Peel Region

DOCUMENT - 2026-353T
INTERIOR RENOVATIONS FOR PEEL REGIONAL POLICE AT 180 DERRY ROAD EAST, MISSISSAUGA
ADDENDUM NO 2

EMIL V. KOLB CENTRE
PEEL REGIONAL POLICE FACILITY
INTERIOR RENOVATION PROJECT
180 DERRY ROAD EAST, MISSISSAUGA, ON L5T 2Y5

1 A301 REFLECTED CEILING PLAN- NEW- SECOND FLOOR
SCALE: 1:100

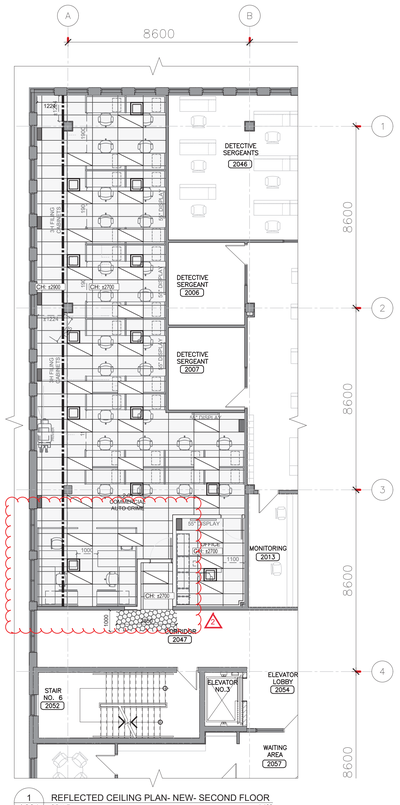
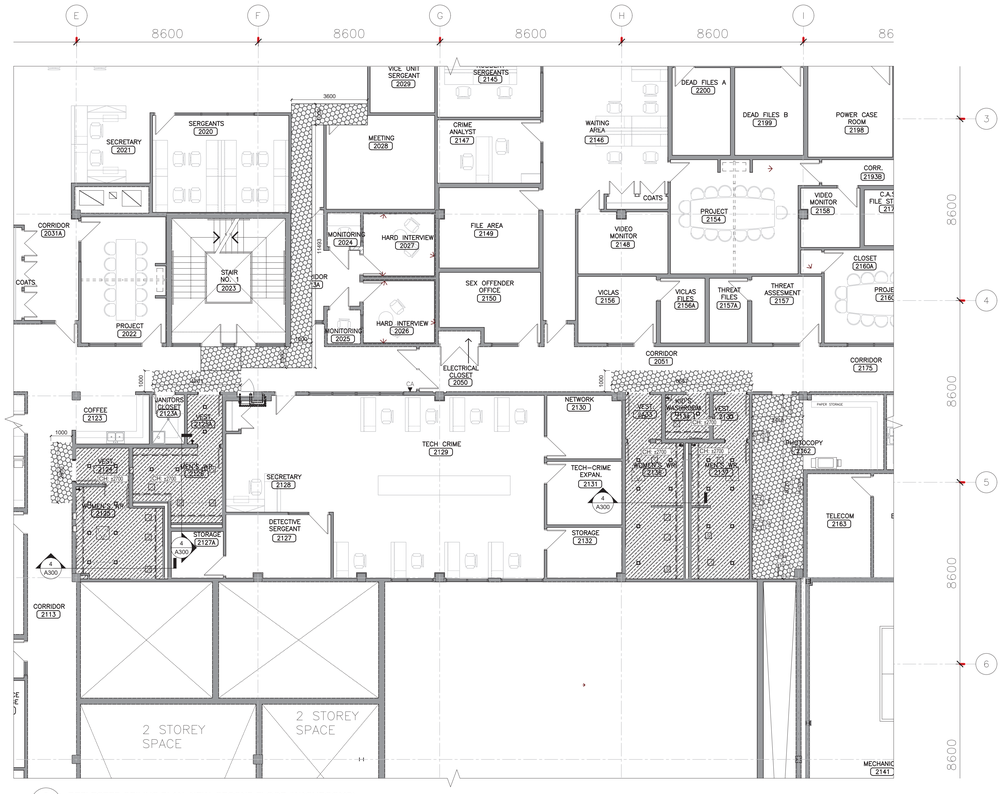
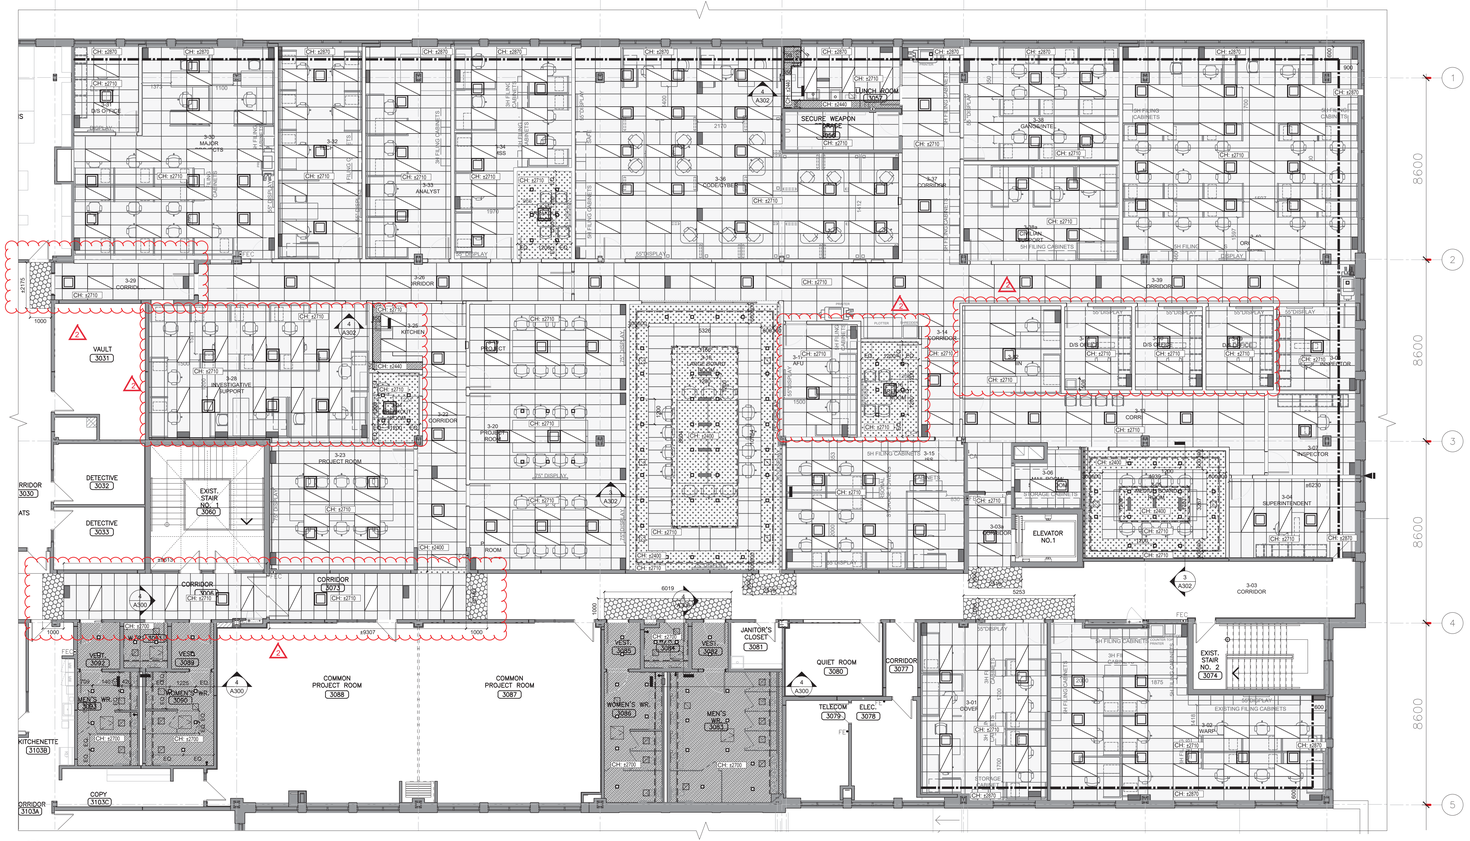
7. Refer to attached drawing A301 for revised third floor reflected ceiling plan issued for ADD#02 dated June 15th, 2026.

1 A401 FLOOR FINISH PLAN- NEW- SECOND FLOOR
SCALE: 1:100

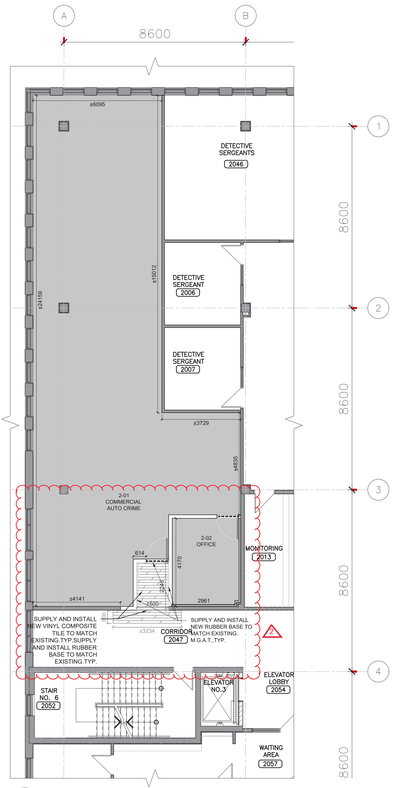
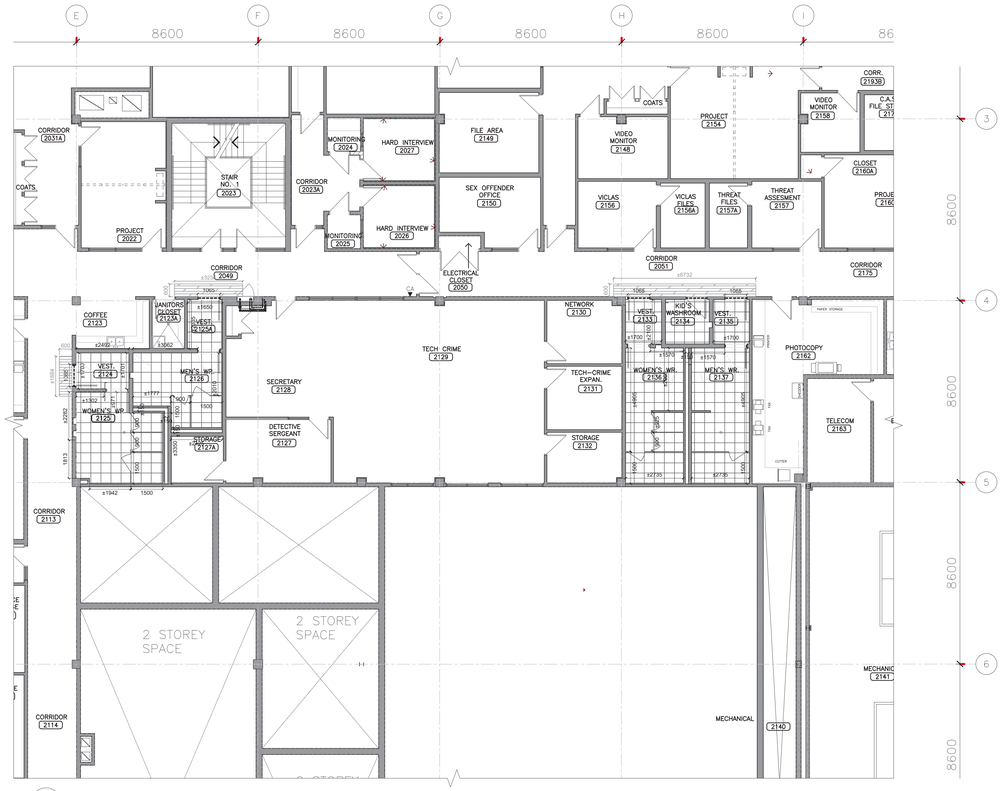
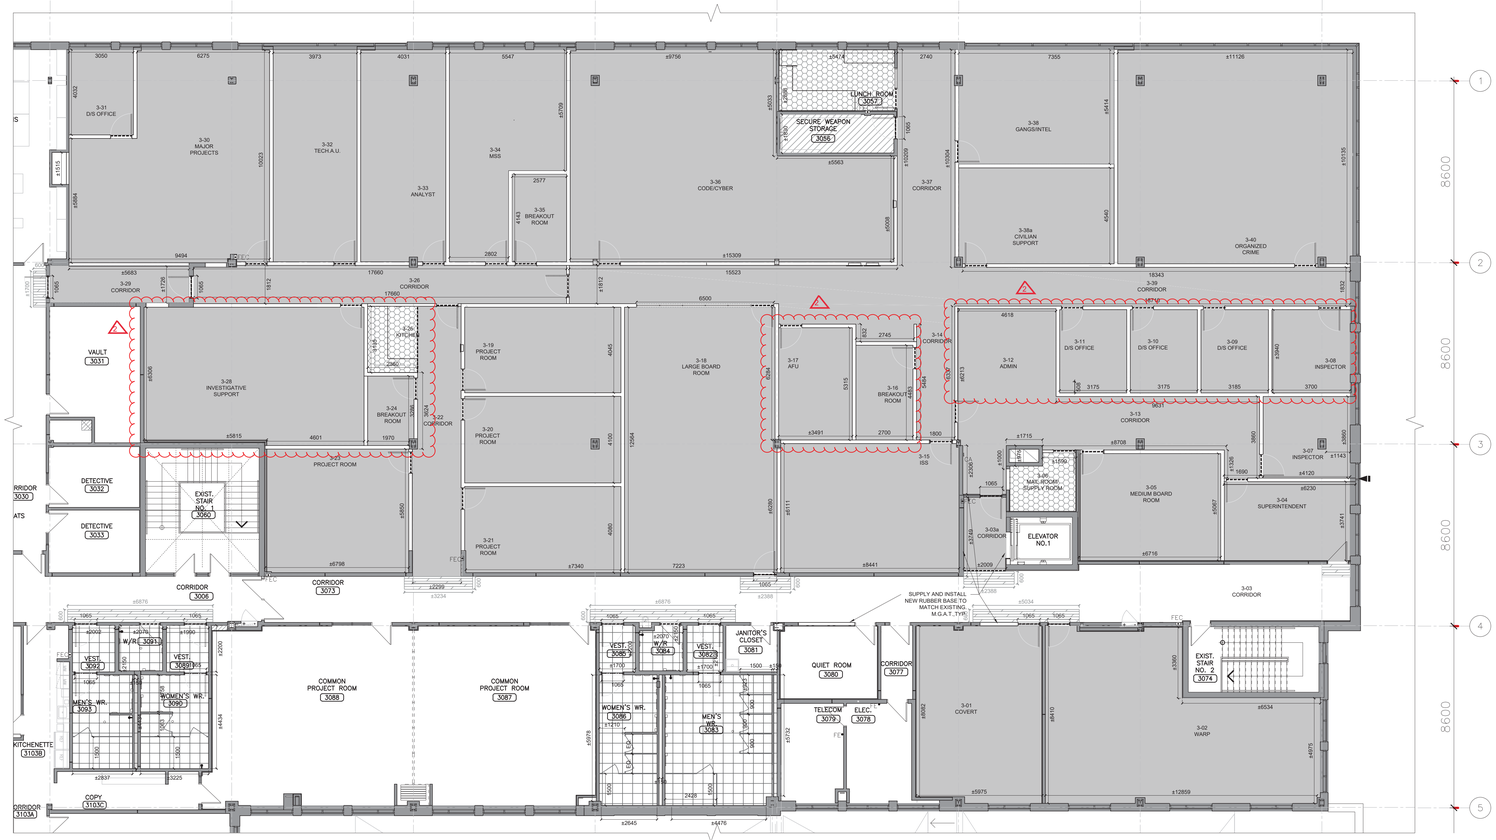
8. Refer to attached drawing A401 for revised floor finish plan issued for ADD#02 dated June 15th,2026.

1 A402 WALL FINISH PLAN - BASEMENT
SCALE: 1:100

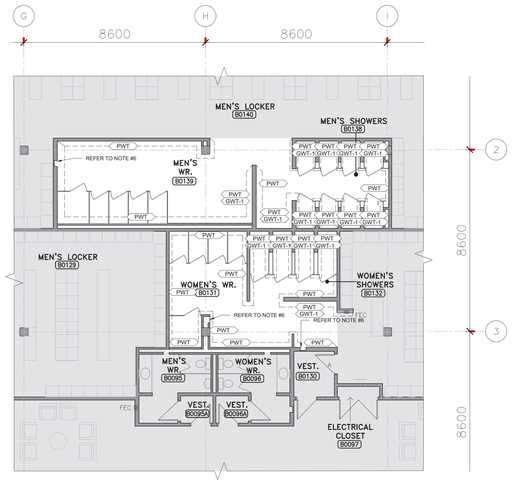
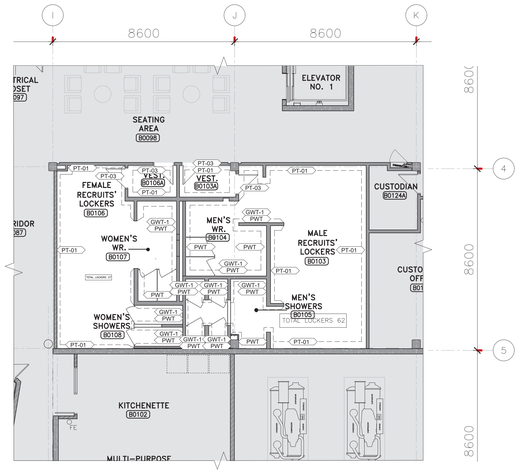
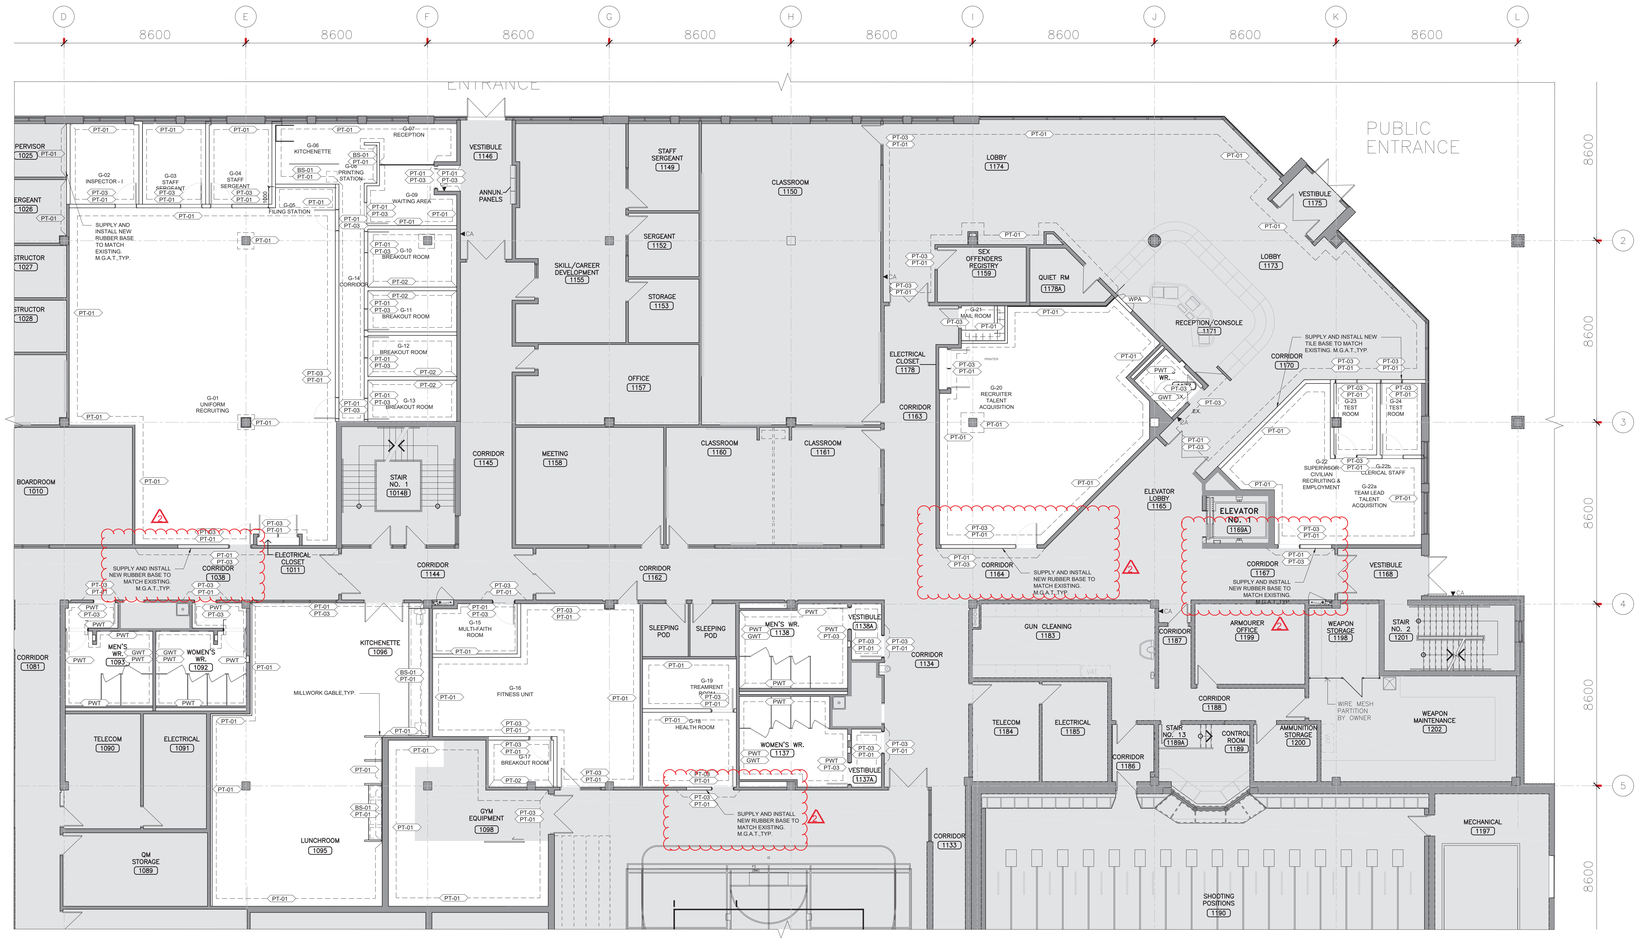
9. Refer to attached drawing A402 for revised wall finish plan for ADD#02 dated June 15th,2026.

1 A403 WALL FINISH PLAN- SECOND FLOOR
SCALE: 1:100

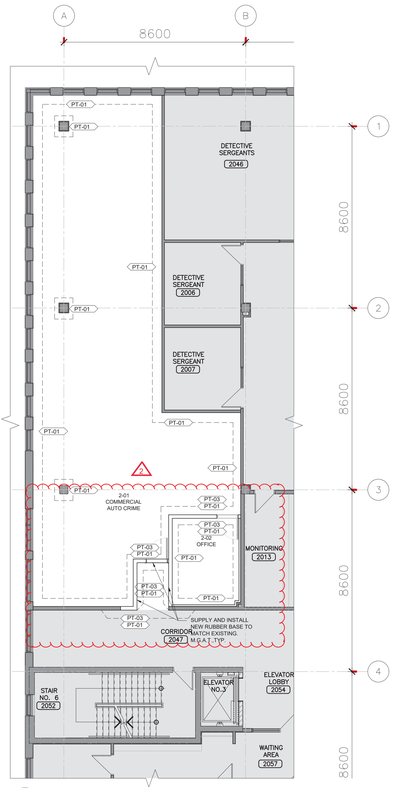
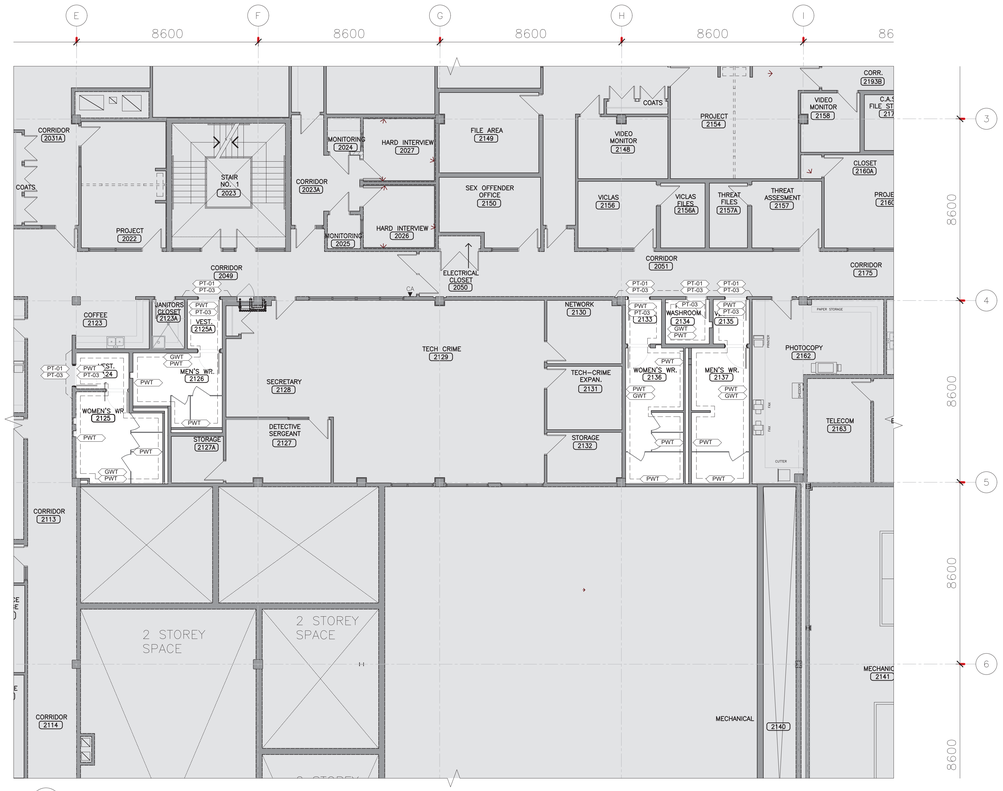
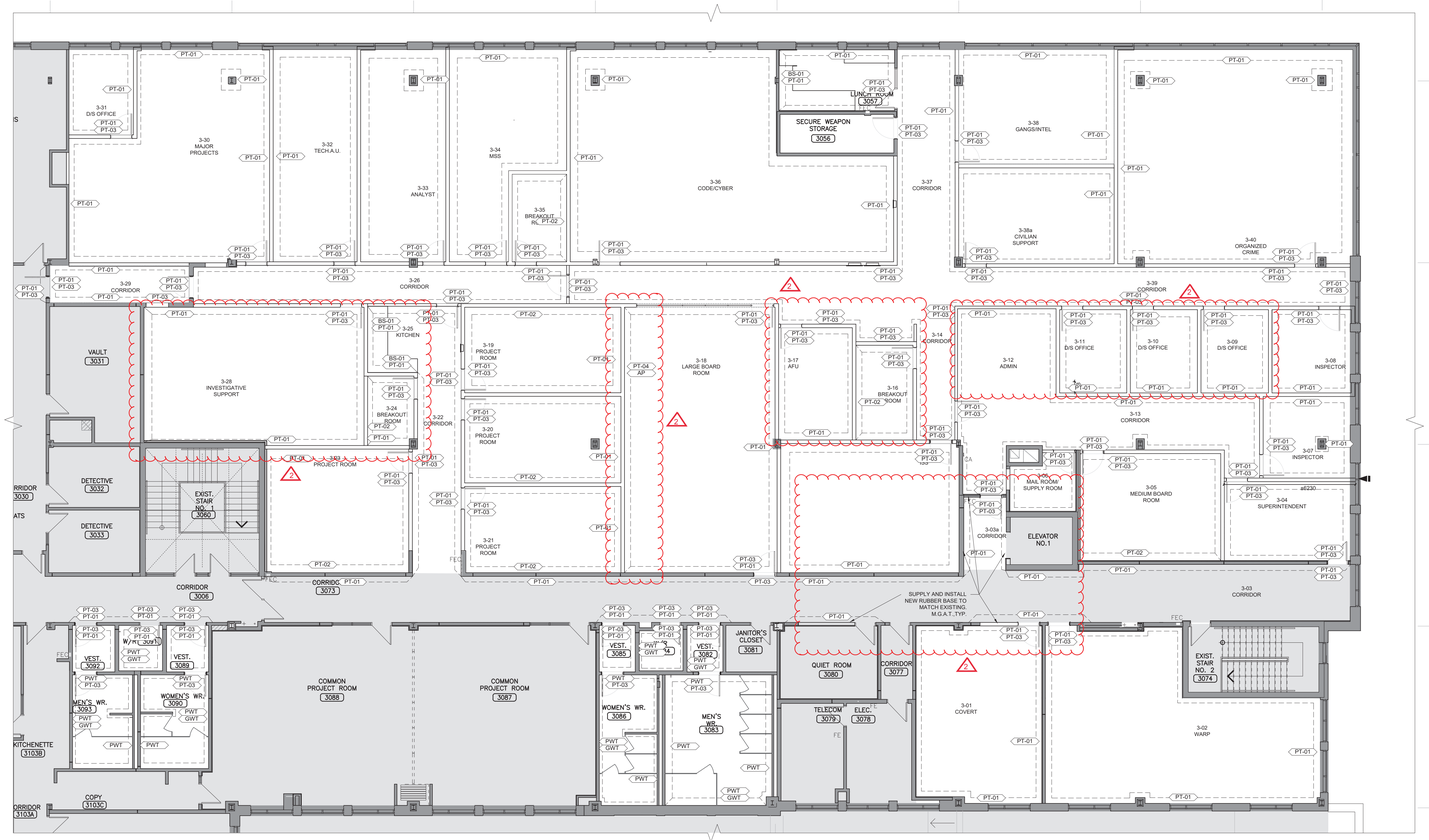
10. Refer to attached drawing A403 for revised wall finish plan for ADD#02 dated June 15th,2026.

1 A500 INTERIOR ELEVATION KEY PLAN - BASEMENT FLOOR SHOWER/ WASHROOM
SCALE: 1:50

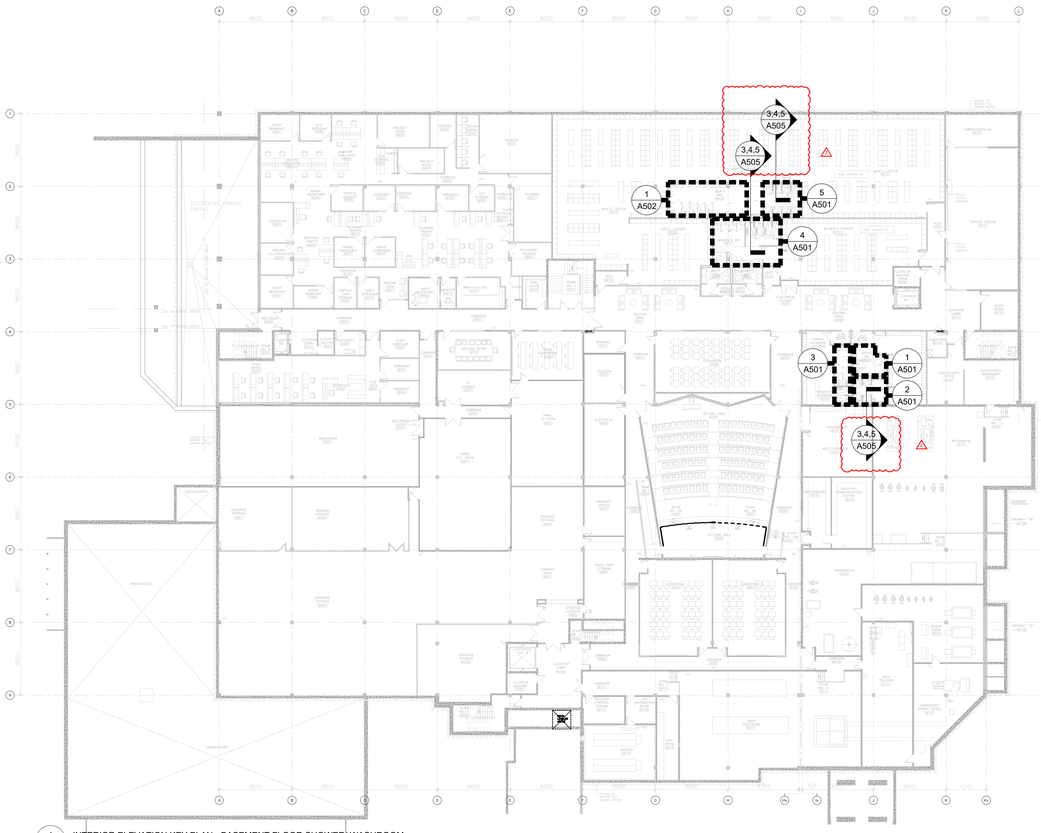
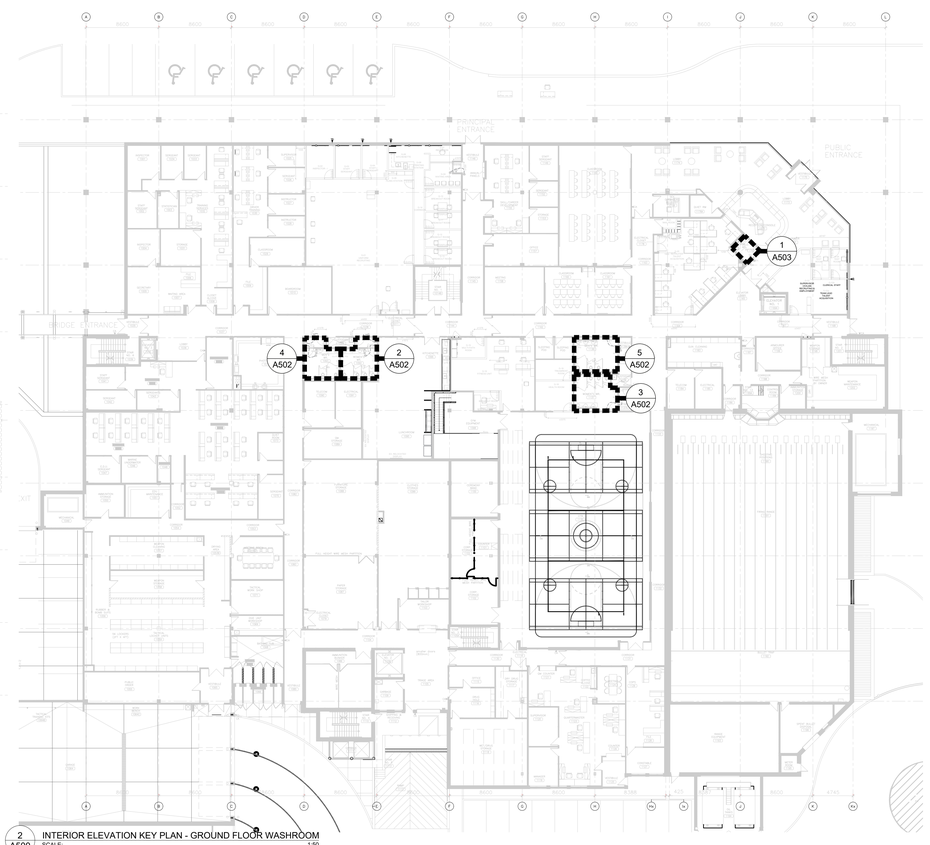
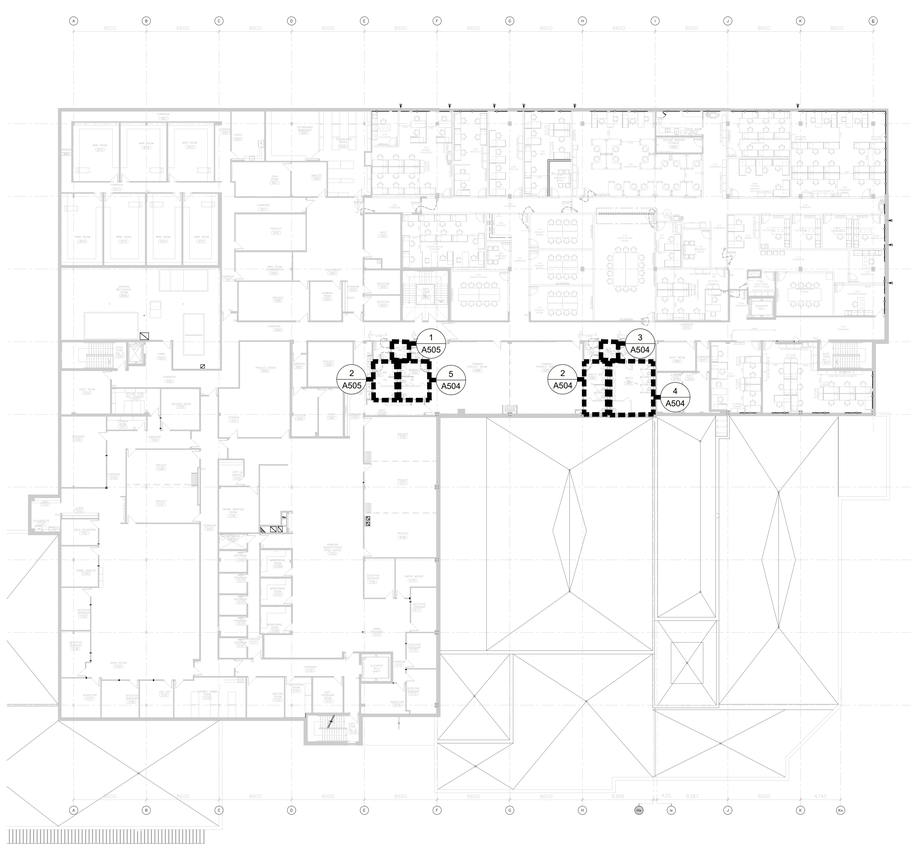
11. Refer to attached drawing A500 for revised key plan issued for ADD#02 dated June 15th, 2026.
